December 8, 2023  
223440

**Re: 1314 AND 1316-1318 WHARF STREET HERITAGE BUILDING  
TAX INCENTIVE PROGRAM THIRD-PARTY STRUCTURAL ASSESSMENT**

This report focuses on the assessment of the proposed seismic design strategy of the heritage structure and commentary on the construction costs associated with seismic restraint of the retained heritage components.

**Figure 24 – Basement Level Heritage Retention Plan (As Proposed by Developer)**

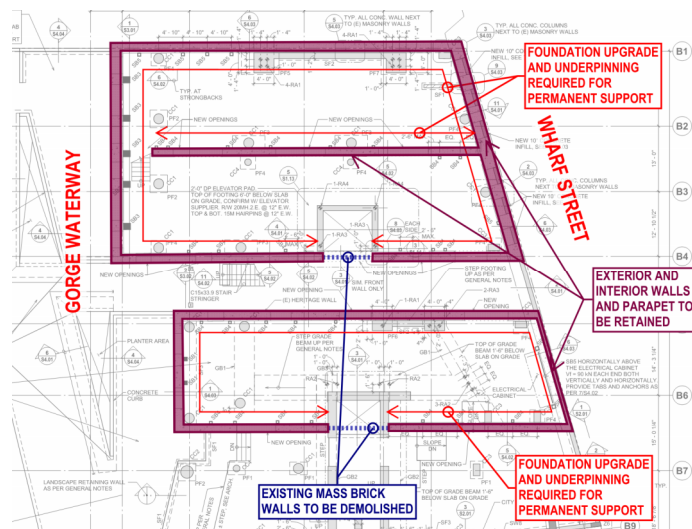
The proposed retrofits for this project are in alignment with the retention strategy, with the exception of the replacement of the replacement of the wood floor and roof framing for 1316-1318 Wharf Street and the demolition of the same elements for 1314 Wharf Street to suit new structure above the heritage structures, with concrete slabs replacing the wood framing for both structures. Comments regarding development are beyond the scope of this report, but it should be said that the floor and roof diaphragms would have required upgrade regardless of any new framing built above.

The new development has proposed to retain the following heritage items:

- All exterior façade wall framing for both structures, including parapets and cornices

- Interior bearing wall for 1316-1318 Wharf Street

The following items have been demolished:

- Wood roof framing, including wood truss joists and ship-lap decking for both 1314 and 1316-1318 Wharf Street
- Wood floor framing, including 2x joists, dropped heavy timber beams and posts, and ship-lap decking for 1314 and 1316-1318 Wharf Street

Figure 28 – Typical Wall Strong-Back Connection

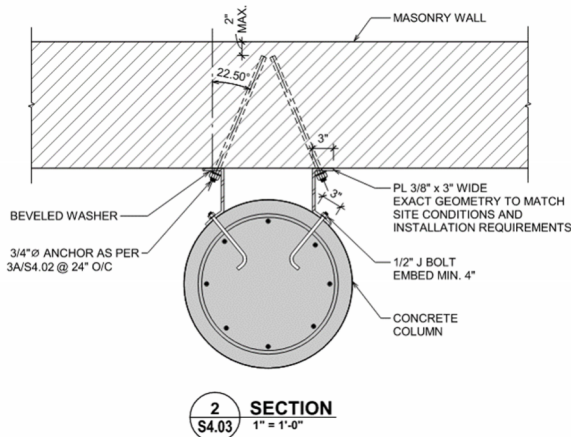
The brick and stone wall façades do not have sufficient out-of-plane capacity to resist horizontal lateral movement in a seismic event (i.e. pulling away from the main building) and will require back-up framing. The façades will need to be tied back to the foundation, at-grade and roof level framing with supplemental drilled and epoxy-grout embedded threaded dowels connected to concrete and steel strong-back beams and posts. Refer to Figures 24, 25 and 26 for plan drawing excerpts from the project structural drawings of layout of exterior and interior walls to be retained, as well as Figures 27-30 for typical strong-back layout and connections. These details are typical for the north and south walls for both 1314 and 1316-1318 Wharf Street.

The existing floor and roof framing will be removed and replaced with structural suspended concrete slabs. These slabs will be used to support the strong-back framing, as well as directly supporting the interior stone wall at the floor level by casting the slabs against the wall; the adjacent concrete and steel columns support the vertical loading such that the stone wall does not support any loading beyond its own self-weight.

Figure 31 – 1314 Wharf Back Façade Support

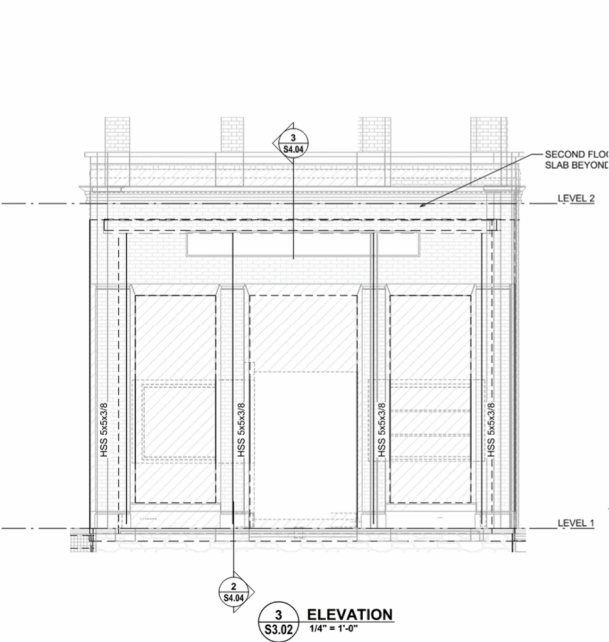
Additional to the typical strong-back details discussed in the preceding paragraphs, the front and back elevations (i.e. east and west elevations) have specific back-up framing layouts; refer to Figures 31-34 for elevations. Structural steel members are to be utilized for the strong-back supports, with the exception of the west elevation of 1316-1318 Wharf Street where the intent is to reuse existing heavy timber members.
